# *Review of Abatement Factors for New Activities Proposed for the Energy Saver Incentive*

*Prepared for  
Department of Primary Industries*

March 2010

**Figure 1: Star Rating of Televisions Registered February 2010**

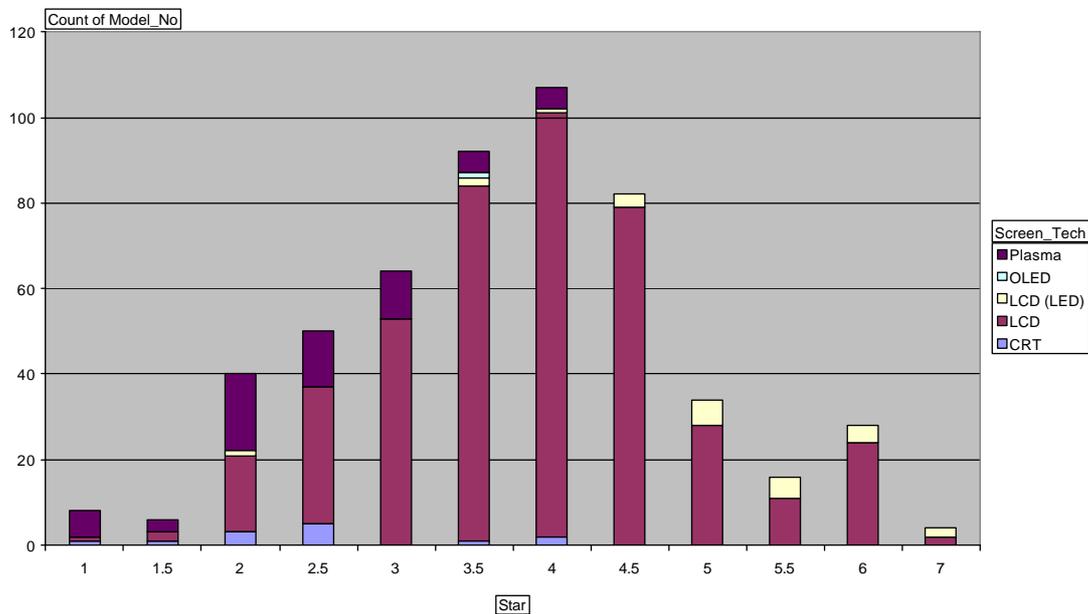
The reasoning and calculations for determining the energy savings appear appropriate. However, one of the major assumptions of the analysis is incorrect. The analysis assumes the sales weighted efficiency of televisions is 3 stars, but research recently conducted by EnergyConsult<sup>2</sup> shows 3.75 stars is the average of model weighted stars for registered televisions at the present time. (See chart below derived from study data). This suggests that the BAU sales weighted efficiency of televisions should probably be assumed to be 4 stars for the abatement calculations, especially considering the rapid increase in higher star rating models in the last 6 months. The calculations will need to be revised to incorporate the higher sales weighted SRI, in cell B47, and the calculation below row 58 will need to be revised accordingly. These changes will decrease the VEEC abatement factors.

Another issue is the definition of what is a high efficiency television. The write up of the 'Purchase of high efficiency television' states that the minimum is a 5 star television, but allowing for the steady improvement in the efficiency of televisions that is expected to occur over the next few years, consideration should be given to raising this base level to 5.5 stars. As televisions are already achieving 7 star ratings, this would still allow for many televisions to obtain VEEC abatements.

Given the steady improvement in the efficiency of televisions, it is also recommended that the assumed BAU sales weighted efficiency of televisions should be revised at the end of the VEET Phase 1 period.
